REACTOR COOLANT SYSTEM

MIDLAND UNITS 1 AND 2

Responses to NRC Questions
Midland 1&2

Question 211.35 (5.4.7)

SHUTDOWN FUNCTIONS AND SYSTEMS

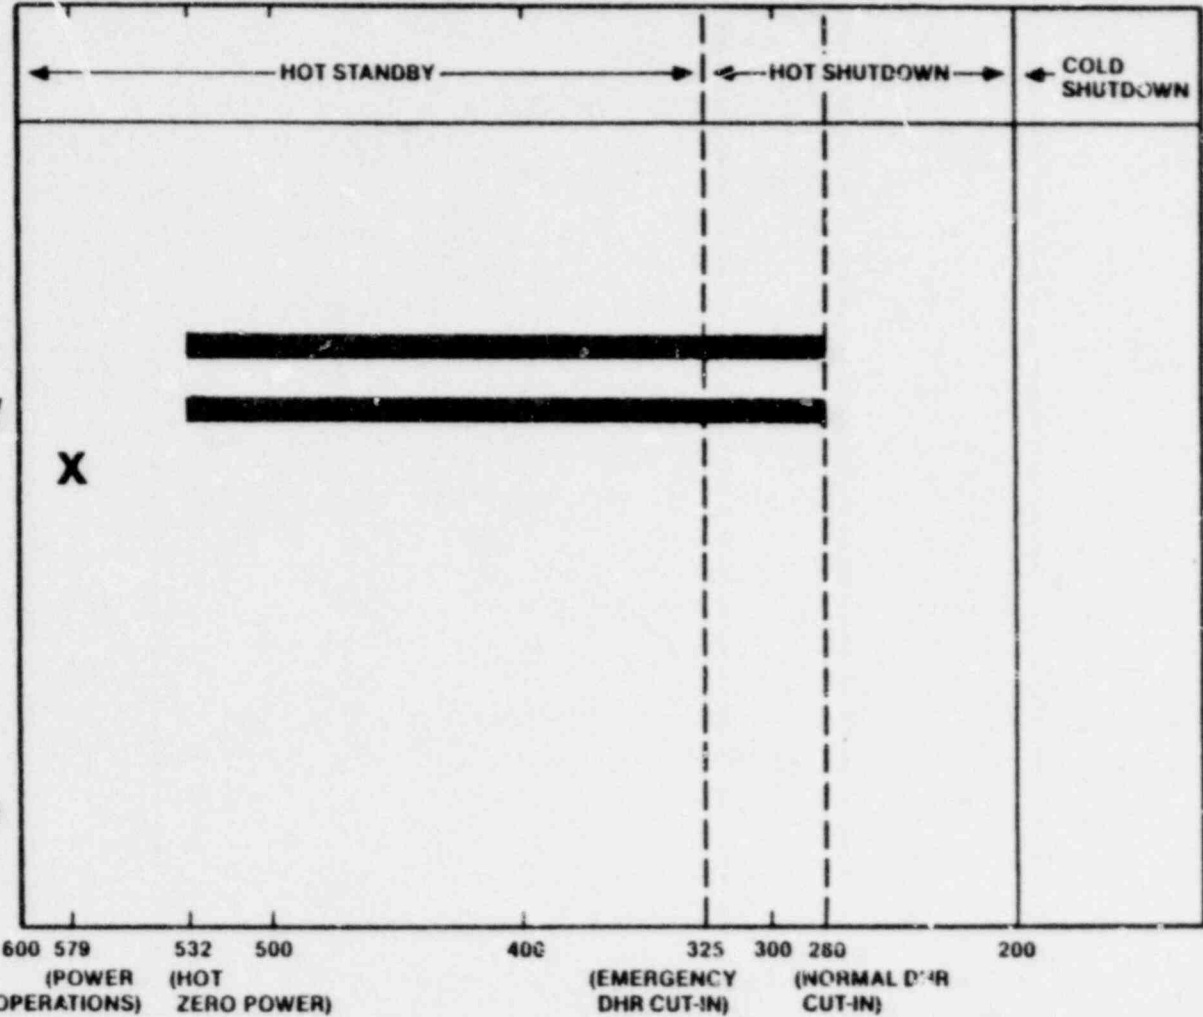
- **NRC POSITION**
Provide Auxiliary Pressurizer Spray or Show Acceptable Manual Actions

- **MIDLAND DESIGN**
Complies: Auxiliary Pressurizer Spray Provided

AUXILIARY FEEDWATER SUCTION CONFIGURATION

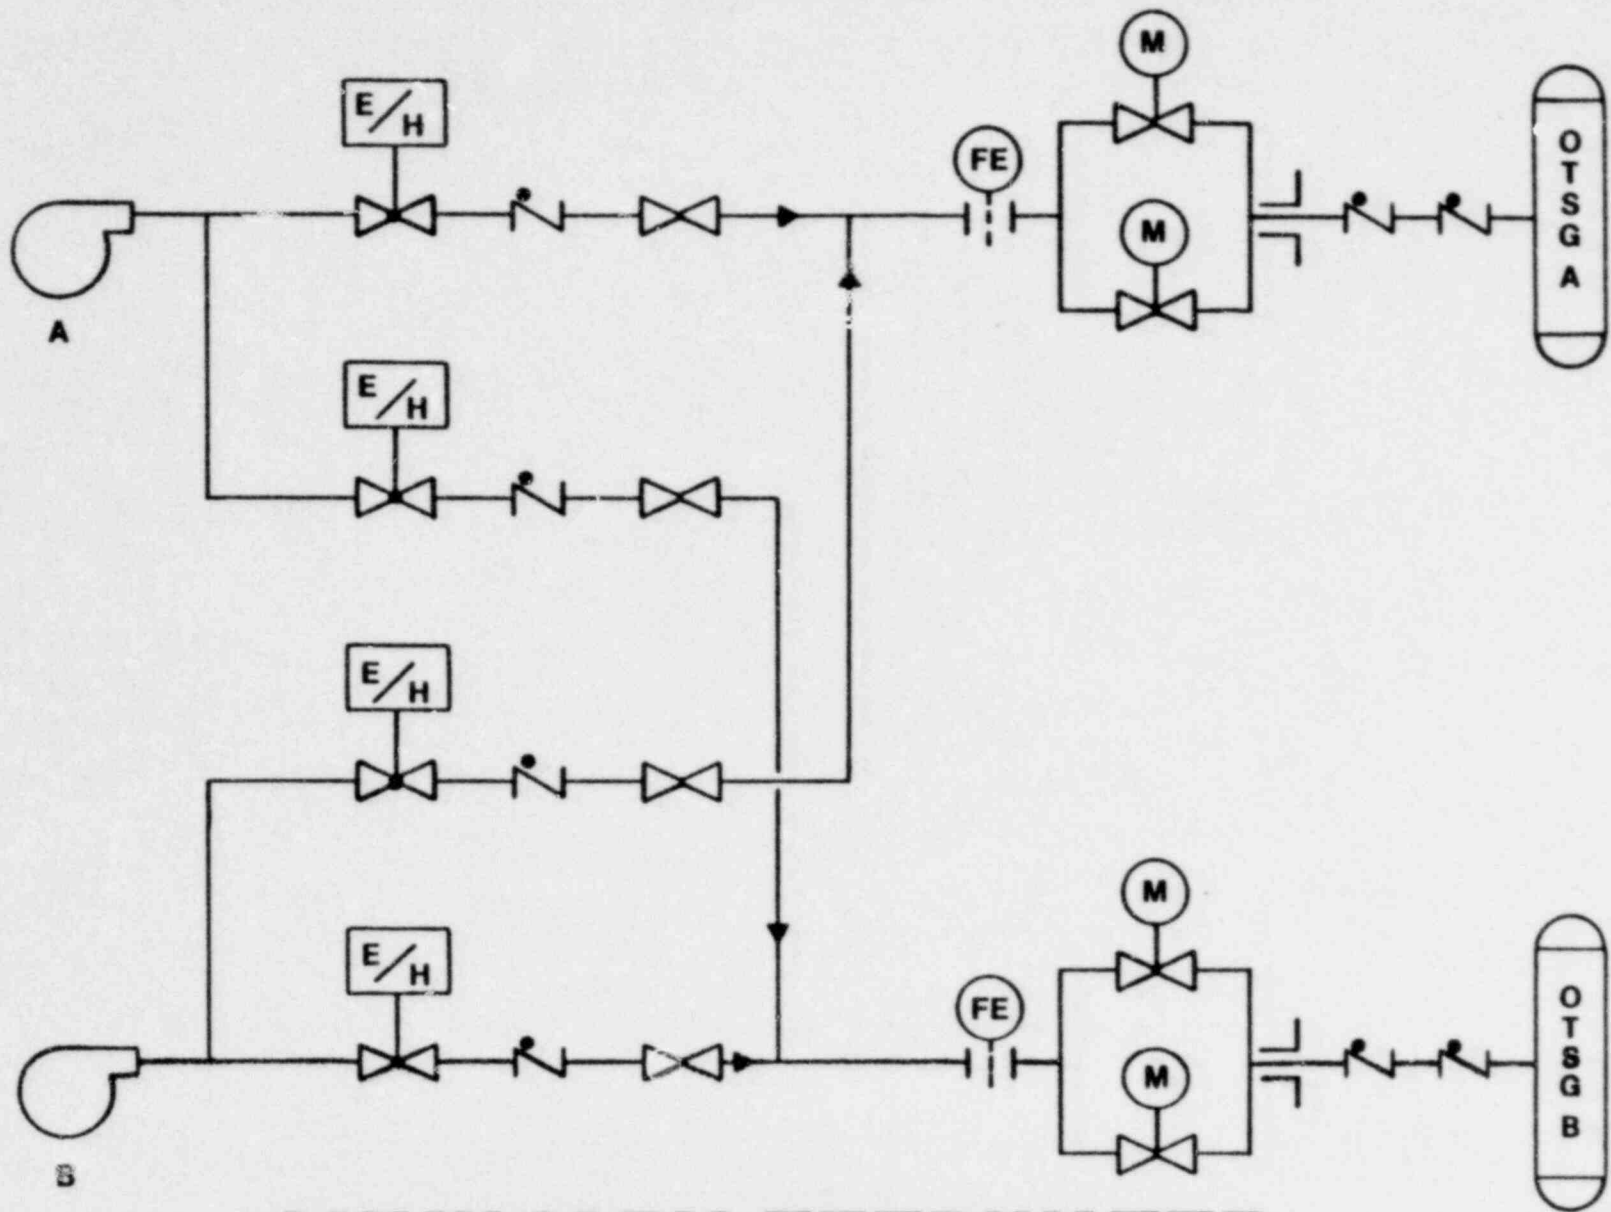
- **NRC POSITION**
Provide Adequate Seismic Category I AFW Supply

- **MIDLAND DESIGN**
Complies: Normal Supply is Nonsafety-Grade Condensate; Automatic Switchover Provided to Safety-Grade Service Water
